# Groundwater Application Review Summary Form

Application # G- 19194

GW Reviewer Darrick E. Boschmann Date Review Completed: 01/25/2023

TO: Water Rights Section Date 01/25/2023  
 FROM: Groundwater Section Darrick E. Boschmann  
 Reviewer's Name  
 SUBJECT: Application G- 19194 Supersedes review of 11/29/2021  
 Date of Review(s)

**Theis Time-Drawdown Worksheet** v.3.00

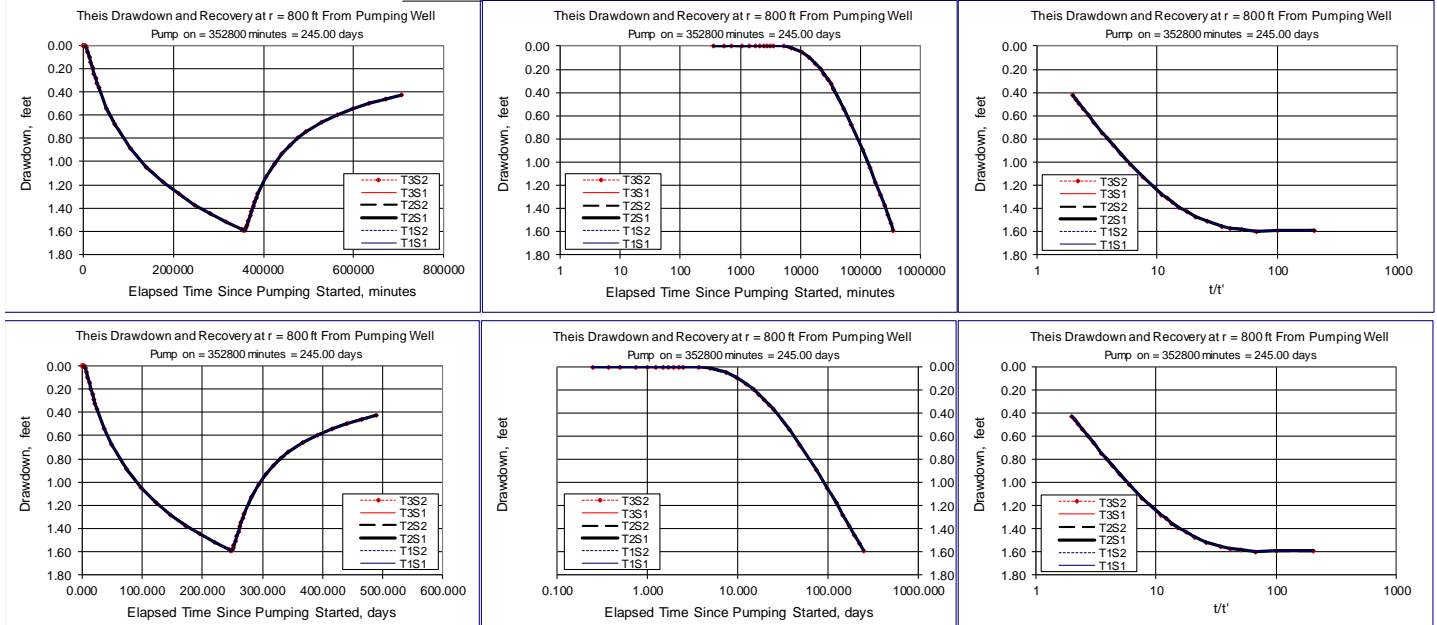
The nearest authorized POD to the proposed well is POD 1 under certificate 60743 (a sump) which is located ~800 feet to the southeast. The potential increase in seasonal interference was calculated using the Theis equation (see attachment). The transmissivity used in the calculation (1340 ft<sup>2</sup>/day) is the mean transmissivity of model layer 1 (basin fill) of Morgan, 1988. The storage coefficient used (0.1) is the value used by Morgan (1988) for model layer 1 (basin fill). At the maximum pumping rate (0.124 cfs) the results indicate an increase in seasonal drawdown of ~1.6 ft.

G-19194 Well 1 - SW1

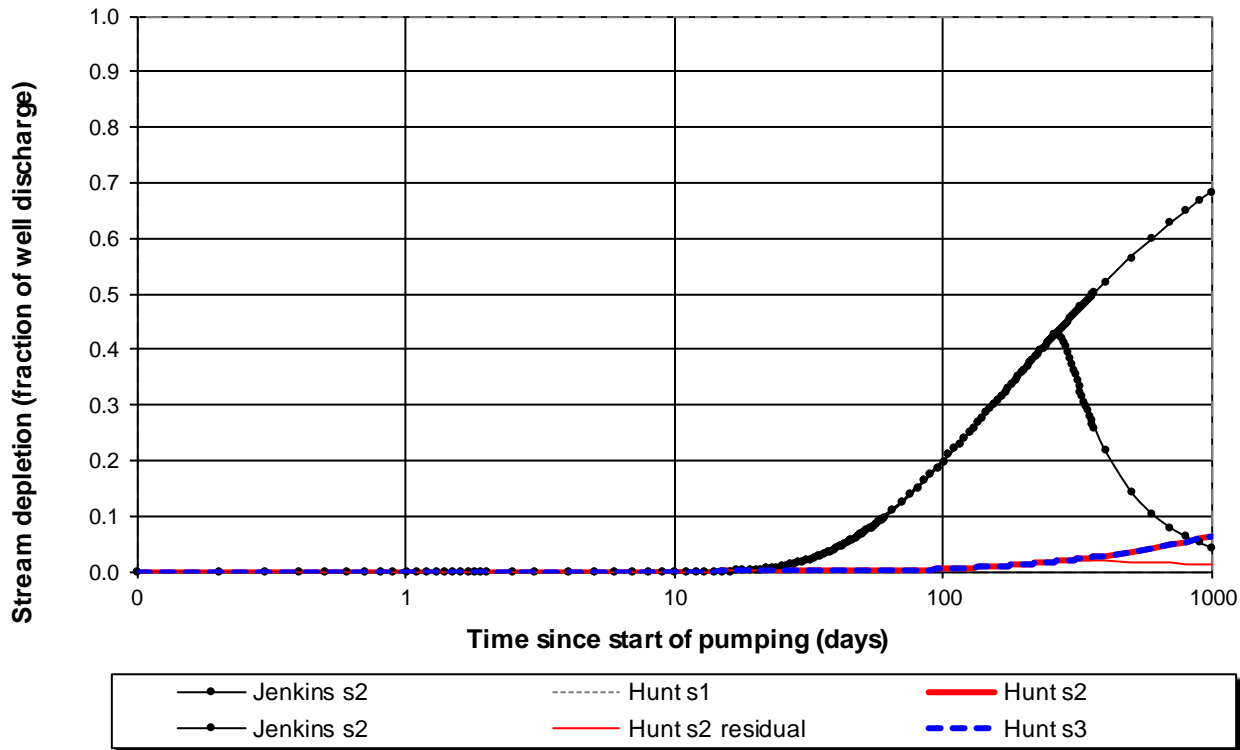
C3a. Hunt (1999) was used to calculate the interference between well 1 with SW1 and SW2. The values used for the calculation are conservative and appropriate until better values become available. The calculations used a transmissivity of 1340 ft<sup>2</sup>/day, the mean transmissivity of model layer 1 (basin fill) of Morgan, 1988. The storage coefficient used (0.1) is the value used by Morgan (1988) for model layer 1 (basin fill). The hydraulic conductivity assigned to the streambed is 0.023 feet/day. See reports attached.

**\*Qw is greater than 1% of 80% natural flow for both SW 1 and SW2.**

PSI is assumed for Well 1 to SW #1 and Well 1 to SW #2.
